Original Rev for Memco

Took T3-8I8O design rev14 and reworked it for PWM project

POWER

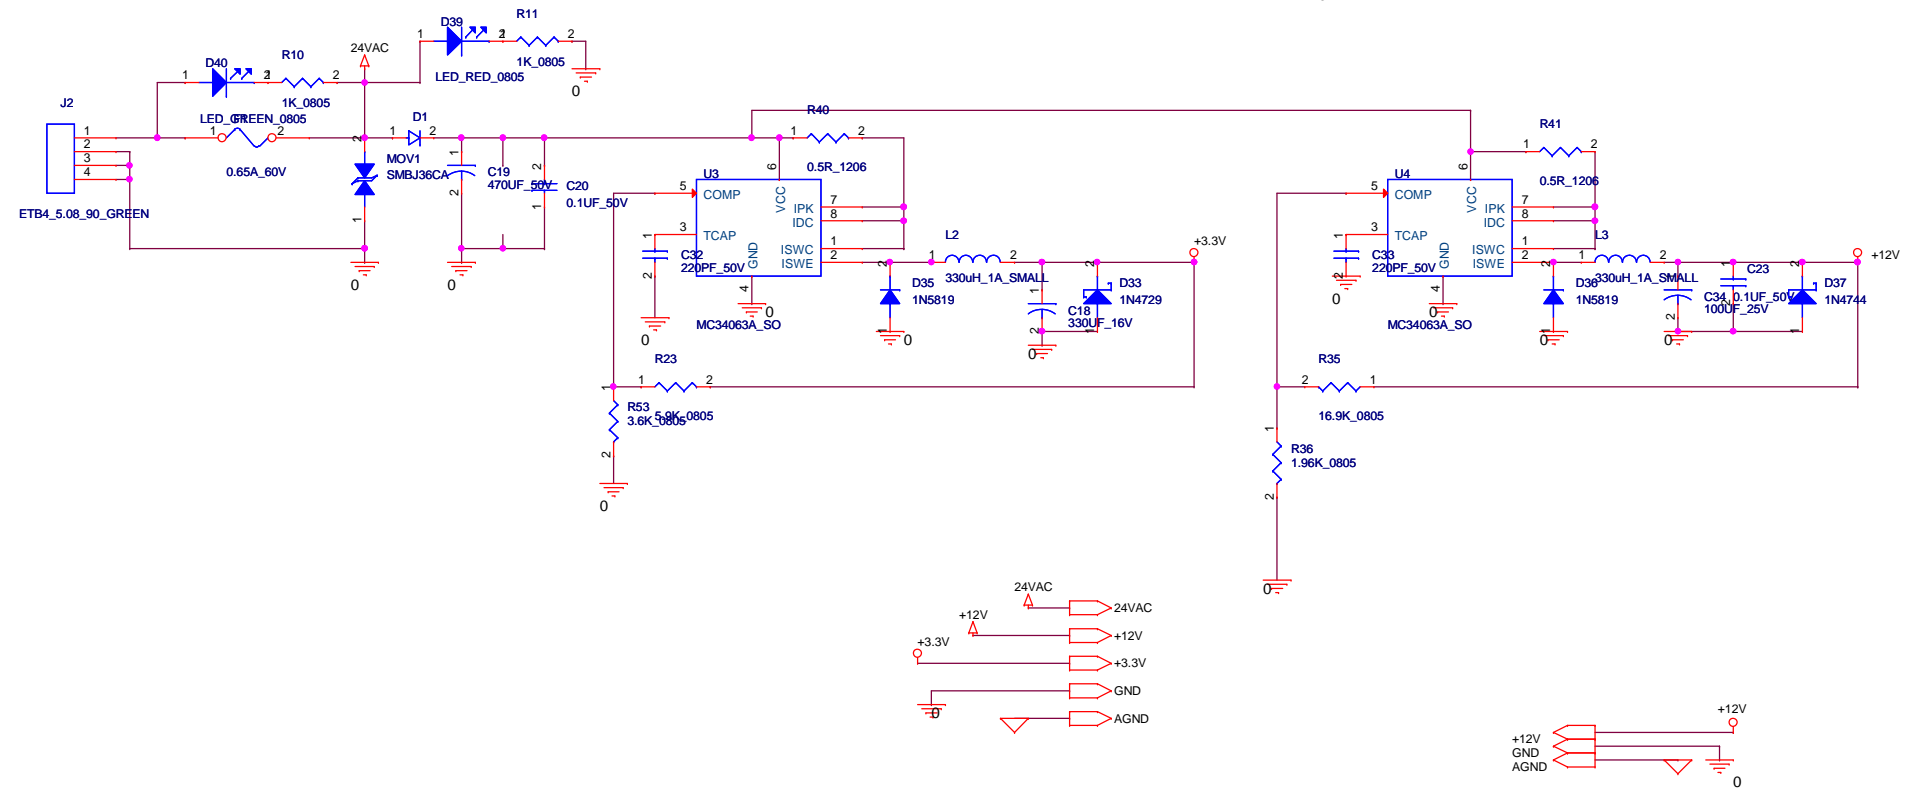
Done: added diode to decrease 5V line for 485 module, it would overheat otherwise

Done: timing cap for power chip changed to 120pF to reduce noise

Done: changed the resistance for power to 1.89 and 5.96 for the 5V supply
